HISTORIC LANDMARK COMMISSION
APPLICATION FOR A CERTIFICATE OF APPROPRIATENESS
OCTOBER 5, 2022
HR-2022-122453
HEIERMAN BUILDING
115 E. 5TH ST.

PROPOSAL

Alterations, demolition, and new construction of an addition to the existing 3-story commercial structure.

COMMITTEE FEEDBACK

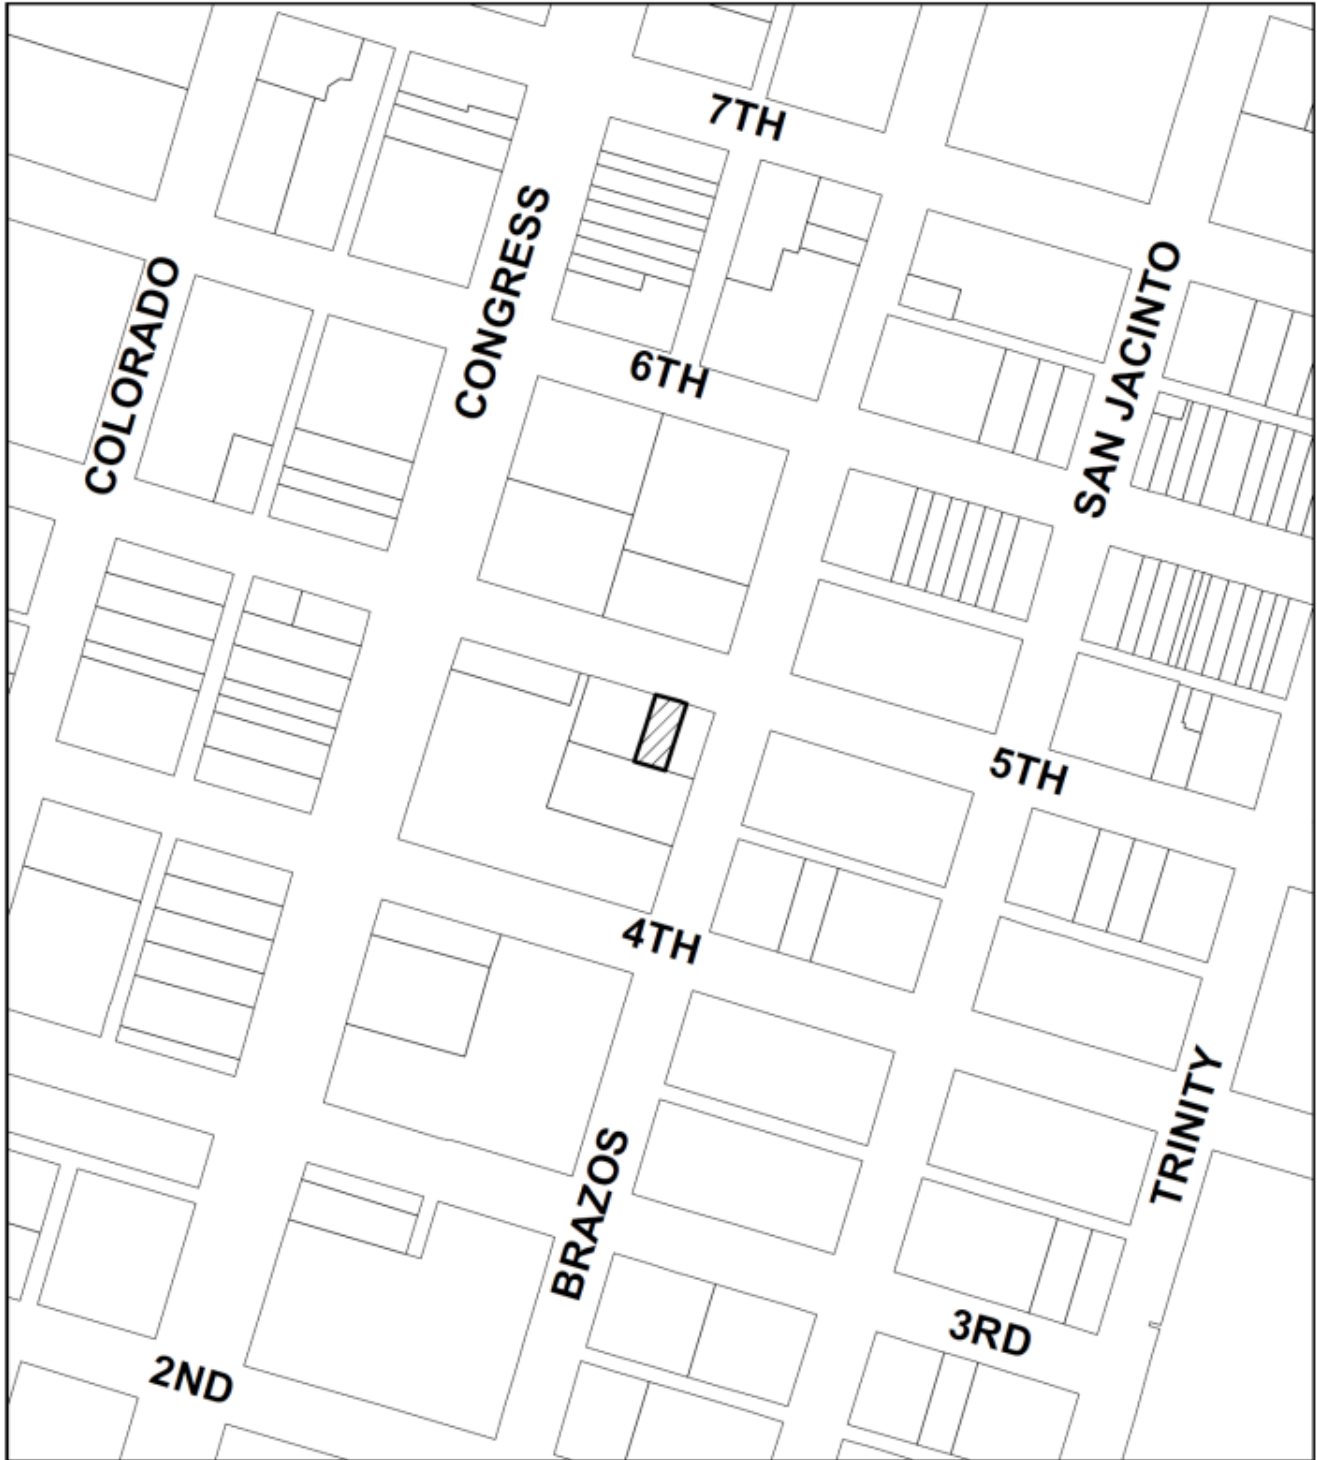
8/8/22: The ARC recommended that the applicant consult the Texas Historical Commission before the HLC as it is a Recorded Texas Historical Landmark (RTHL). The Committee had concerns about the rooftop addition being of appropriate height and compatible materials and suggested a 3D rendering to present how the addition would appear from street level. Further details on the upper-level facade windows and whether they were of historic age and, therefore, should be retained were requested. The ARC advised further research into the original appearance so that any restoration be done to the 1890 period of significance. The ARC advised against replacing something incongruous and non-historic with something incongruous and non-historic (again).

9/12/22: The ARC was pleased with the research done by the applicant. It generally felt more supportive of the top addition if it was of a lighter color that more closely resembled that of the parking structure behind it. The ARC was less supportive of a large amount of the rear wall being removed.

Staff recommends that the Commission approve the application with the following conditions: the top addition be of a lighter color that resembles the Frost tower parking structure behind it and that any recommendations advised by the THC due to the RTHL status be followed.
